SS 584261 FCCC MT45G & MT55G Power Steering Oil Cooler Replacement Parts (306)

2010 2025 FCCC MT45G & MT55G

KIT-P/S COOLER, MT45G/MT55G

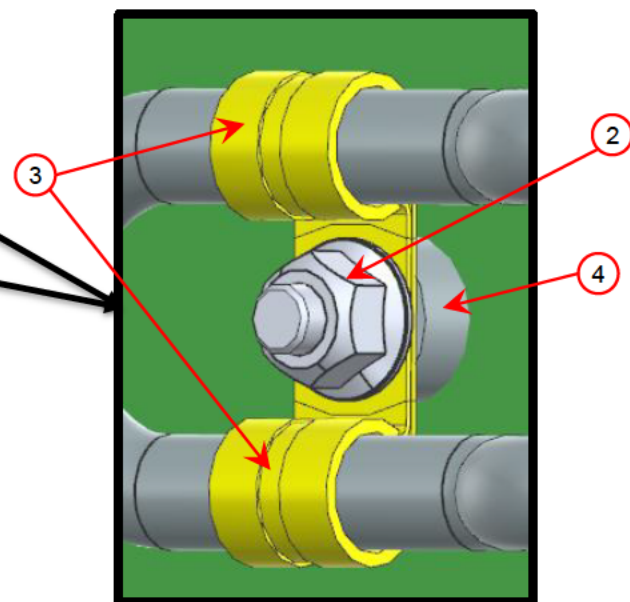
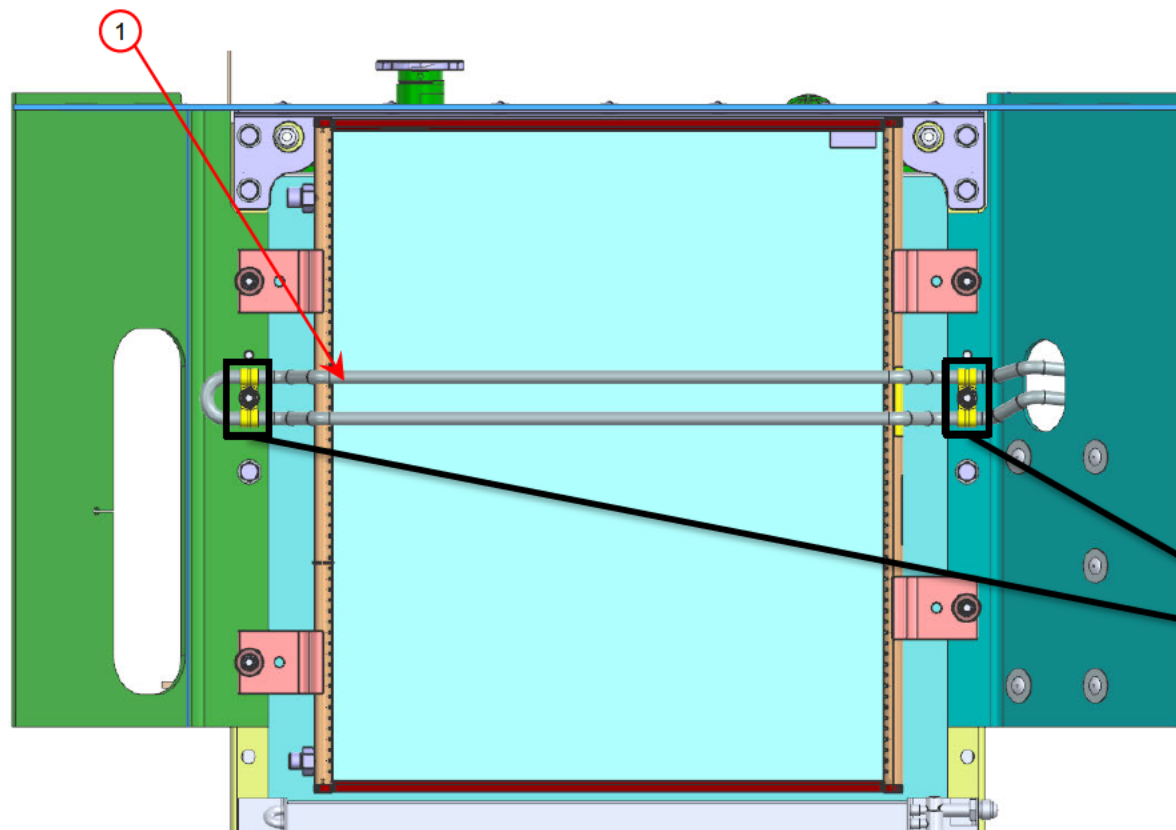
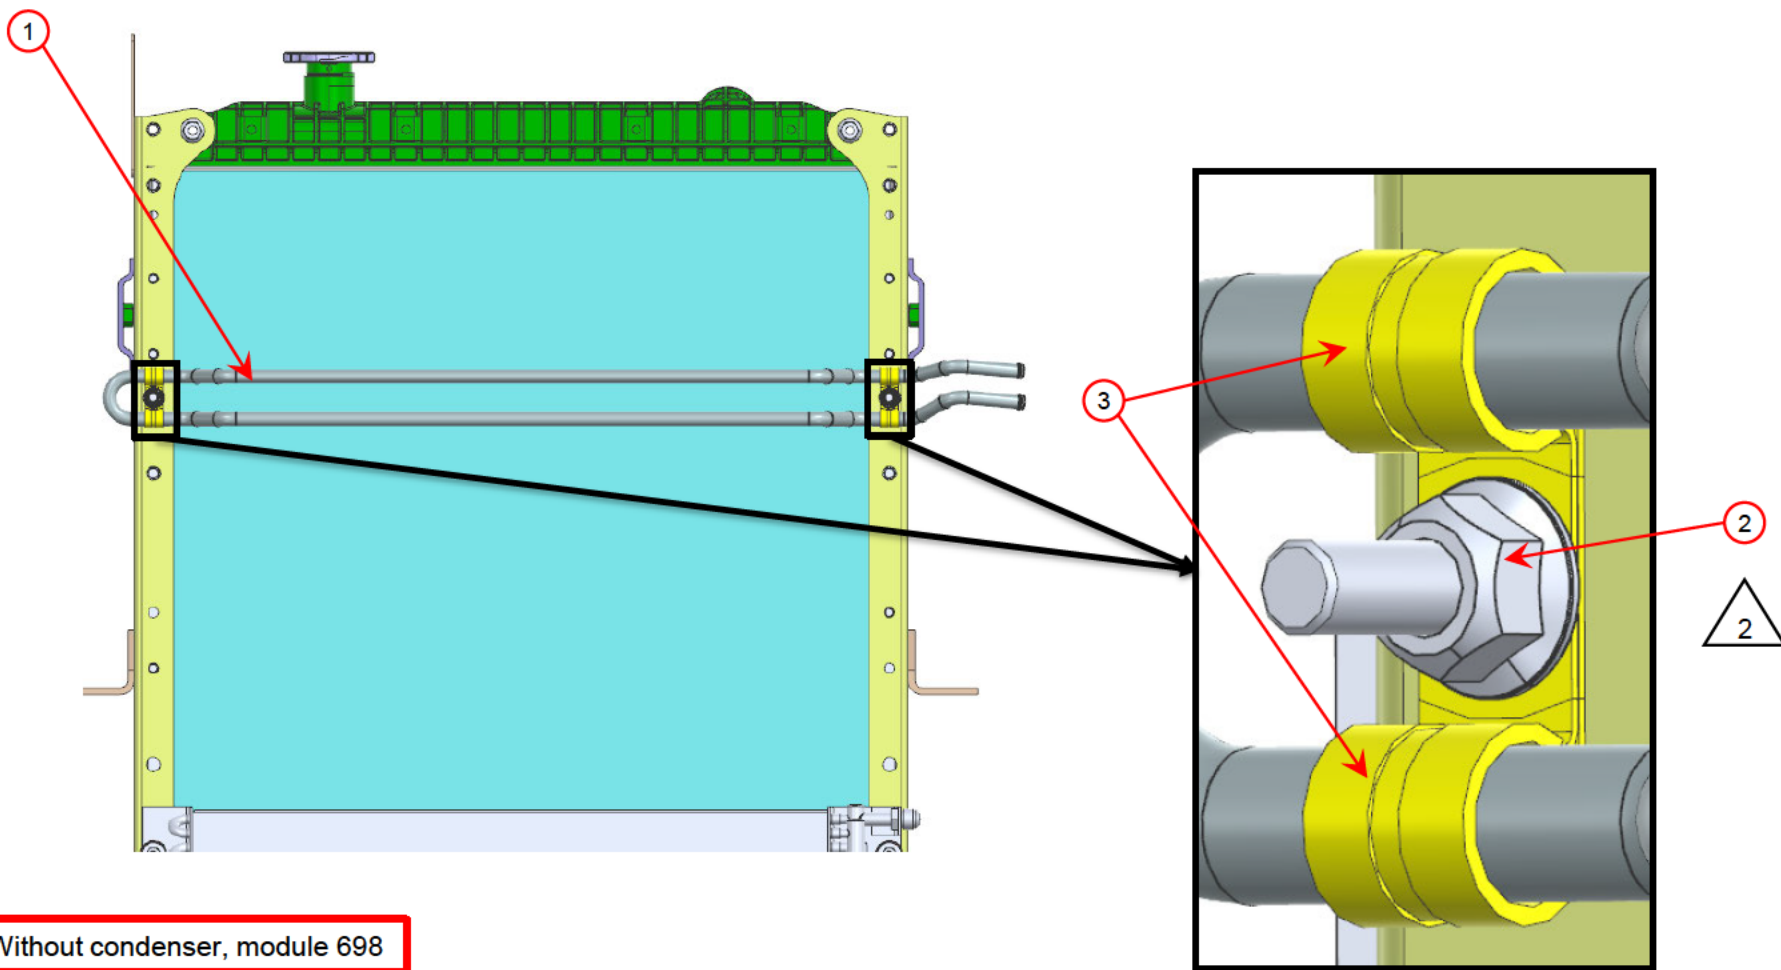
Original P/S oil cooler 05 29962 000 is NLA and being replaced with 05 38367 000, but additional parts are required, as 05 29962 000 & 05 38367 000 are **NOT** interchangeable.

FCCC Engineering developed replacement "kit" of parts as seen on the attached Work Instructions.

1. THIS KIT IS FOR – MT45G/MT55G EQUIPPED WITH 05-29962-000
POWER STEERING COOLER. REFERENCE MODULE 533.

2. ITEM 4 NOT REQUIRED WHEN CONDENSER IS NOT EQUIPPED,
REFERENCE MODULE 698.

3. FASTENER TORQUE CALLED OUT IN BILL OF MATERIAL.
